NOTICE TO TENDERERS NO: 5

TENDER NUMBER: 277Q/2024/25

DESCRIPTION: Construction of a 300M^l Reservoir, Bulk Pipelines and Associated Infrastructure near Muldersvlei

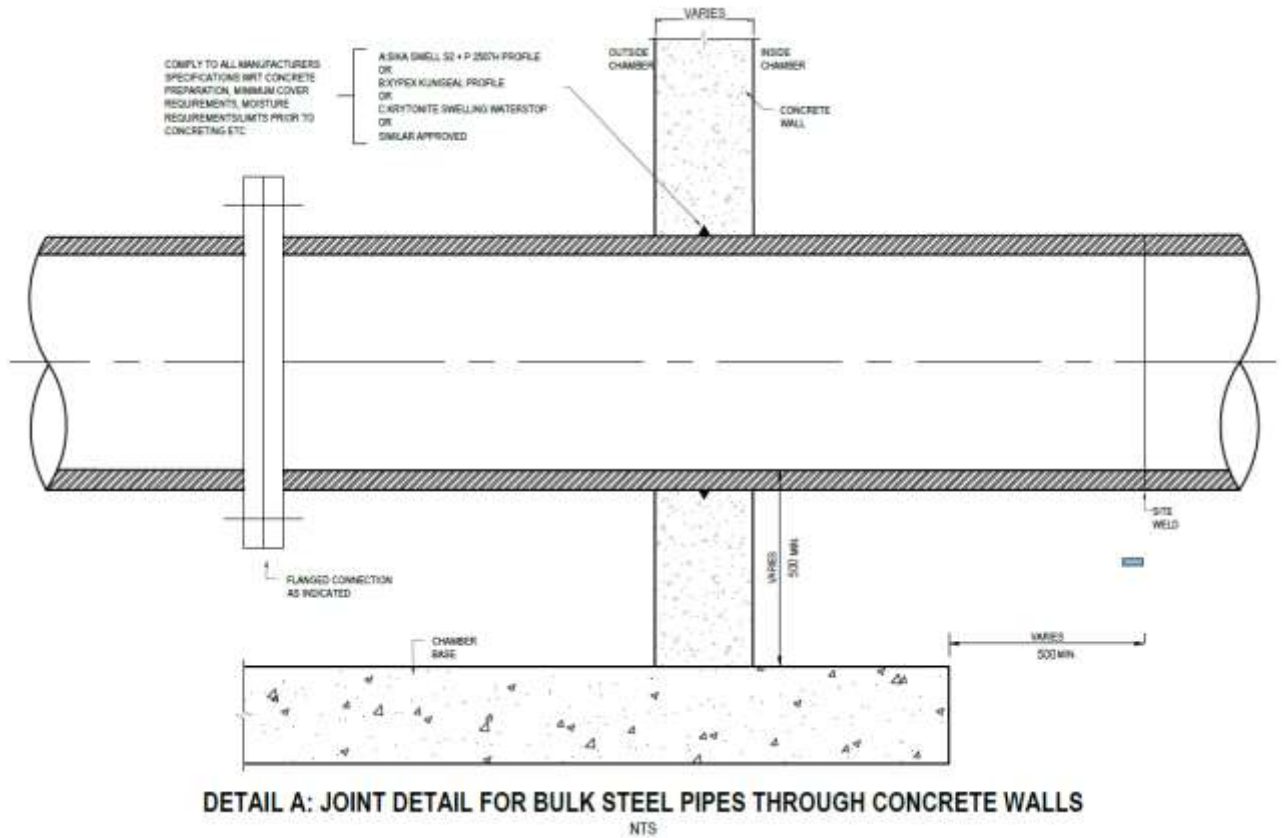
Q: Upon review, we could not locate any specific requirement in the provided specification (Vol 1A – Construction Specifications) relating to puddle flanges, hydrophilic waterbars, or similar waterproofing measures for pipe penetrations through the reservoir or chamber walls.

Are puddle flanges required on all pipe and fitting penetrations through reservoir/chamber walls?

Are any waterproofing systems (e.g., hydrophilic waterbars, mastic, or sealant bands) to be used at these locations?

Should these be dealt with via standard construction drawings, or can they be proposed as part of shop drawings during the construction phase?

A: Refer to Detail A on Drawing 1001757-DRG-CC-4106.

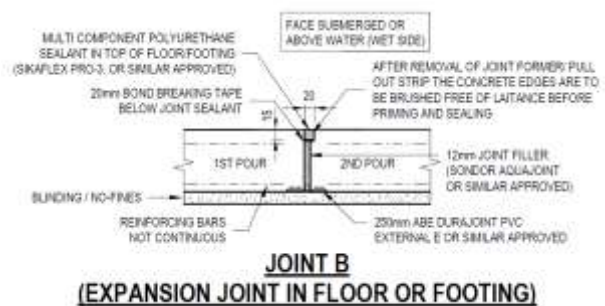
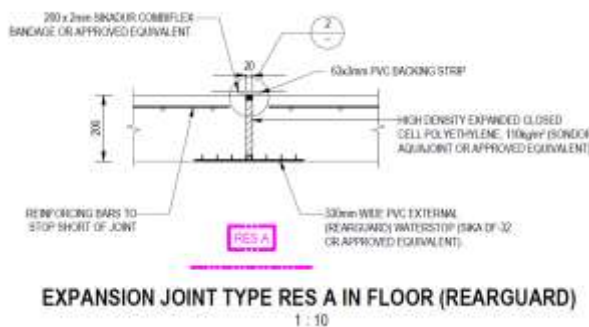
Q: Expansion joint Type Res A in Floor Rearguard (DRG 2522-T0), indicated 1 layer of reinforcing only at the top, whilst typical Joint B (DRG 4002-T0) have two layers, in addition to not having the combiflex system.

A: All joints and details shown on CC-2522 and labelled TYPE RES xxx are applicable to the reservoir structure i.e. inside the 300 ML reservoir structure. All these joints are annotated and referenced on the reservoir structural layouts and sections.

All joints and details shown on CC-4002 are applicable to all other water-retaining structures / water-excluding structures e.g. energy dissipation structure, reservoir spillway structure, pipeline chambers, OSEC fire tank sump etc.

Whether its joint details on CC-2522 OR on CC-4002, the annotations / names of the joints are clearly referenced / shown on the concrete drawings e.g.

- The overflow spillway structure (which ties into the reservoir) has some joints in it that are referenced detailed on CC-4002 such as Joint F.
- The reservoir floors and retaining walls have joints that are all reference don CC-2522.

4.1 STRUCTURES WHICH PENETRATE THE LINING SYSTEM (SANS 10409, SUBCLAUSE 7.4)

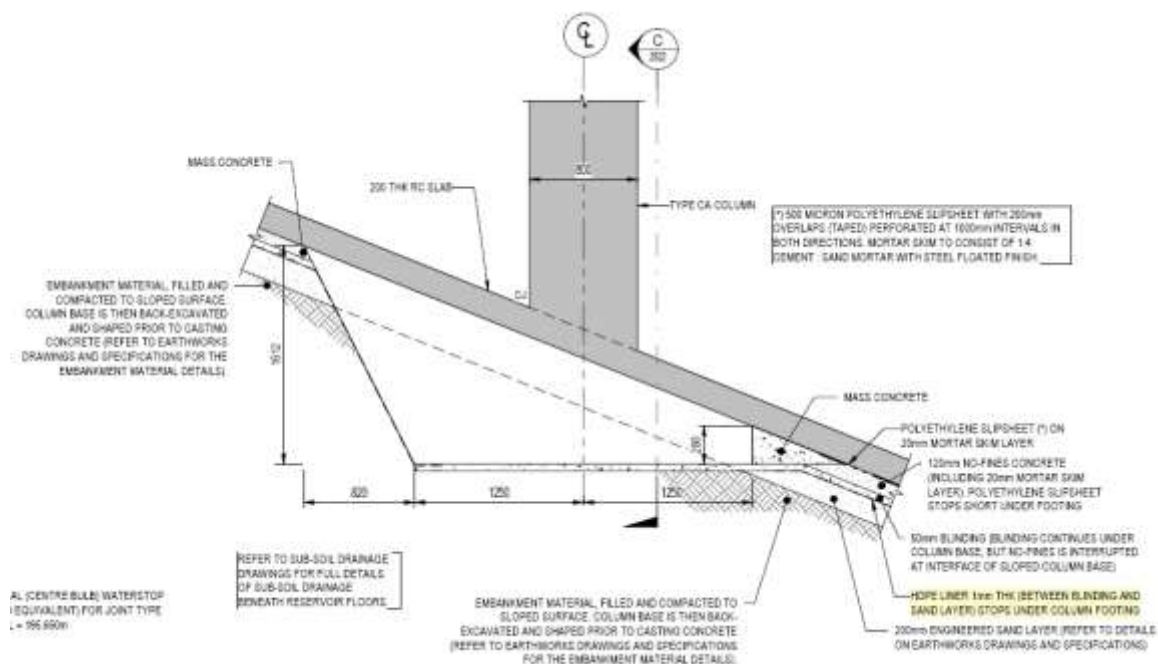
Could you please advise on the detail for the mechanical fixing of the HDPE liner to the column bases on the embankments which protrude the lining system?

A: There is a typical detail on drawing CC-2531 that shows the fixing detail (as shown below).

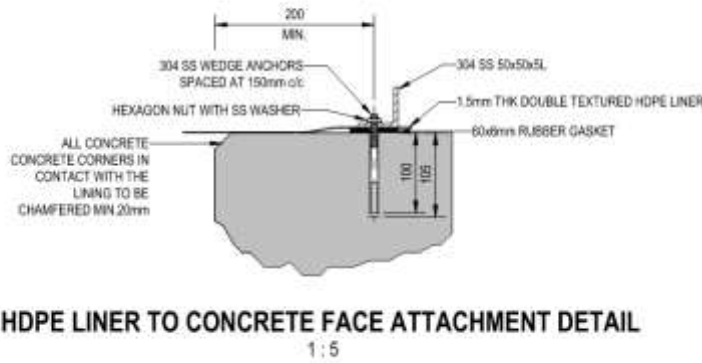
The only drawing that we can seem to find is 1001757-2000-DRG-CC-2522, which states that the HDPE liner stops below the base, with no detail of the fixing to the base (extract below).
